**BIDS AND AWARDS COMMITTEE FOR GOODS**

**Six-Month Lease of High-End Network Cameras and High-Definition (HD) Surveillance, Recording and Monitoring System**

**Bid Bulletin No. CAM 2017-003**

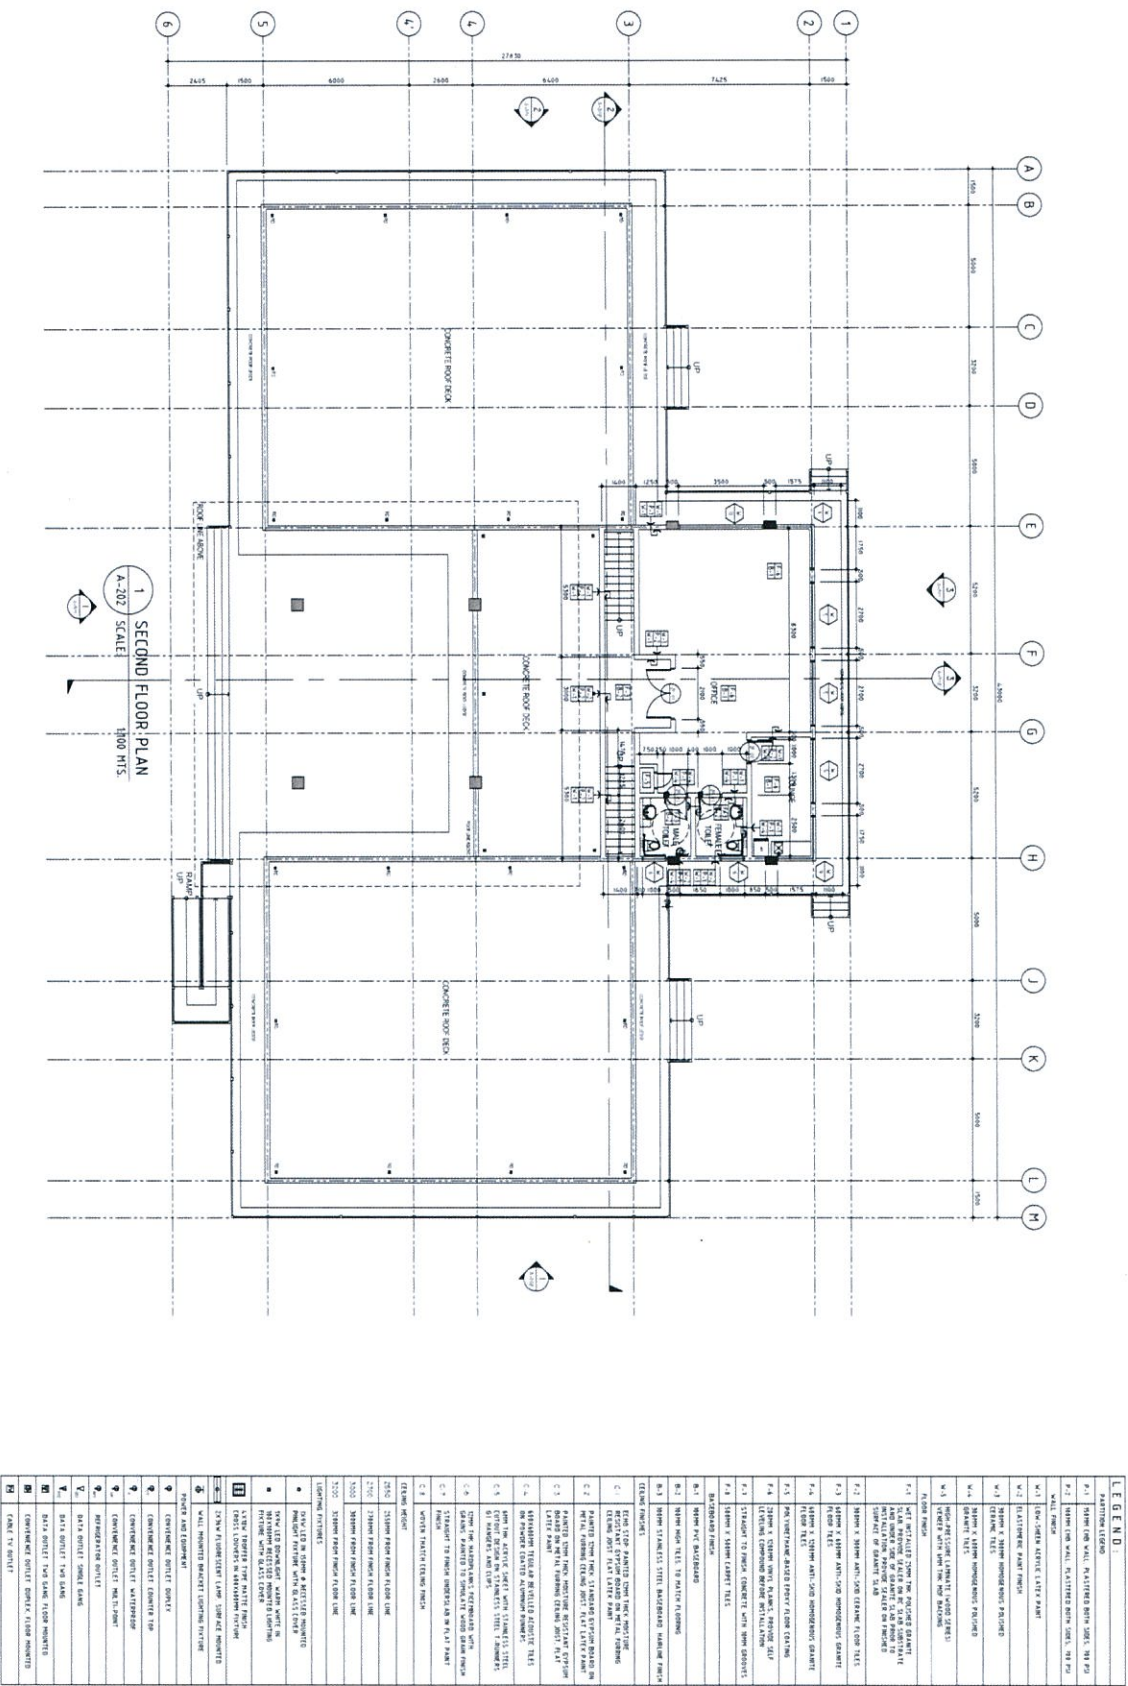
Queries	Answers
<b>Pronet System Integrated Network Solutions, Inc.</b>	
1. Please provide a detailed Single Line Diagram that indicates location of PTZ and Bullet CCTV cameras. Which also includes location of cabinets and number of cameras to be tapped per cabinet.	See Annex A.

5. Updated plan with exact location of CCTV, type of camera (dome, bullet or PTZ)	See Annex A
6. Design, dimension and specifications of fiber optic cabinet and service box	The design, dimension and specifications of fiber optic cabinet and service box are already indicated in the TOR.
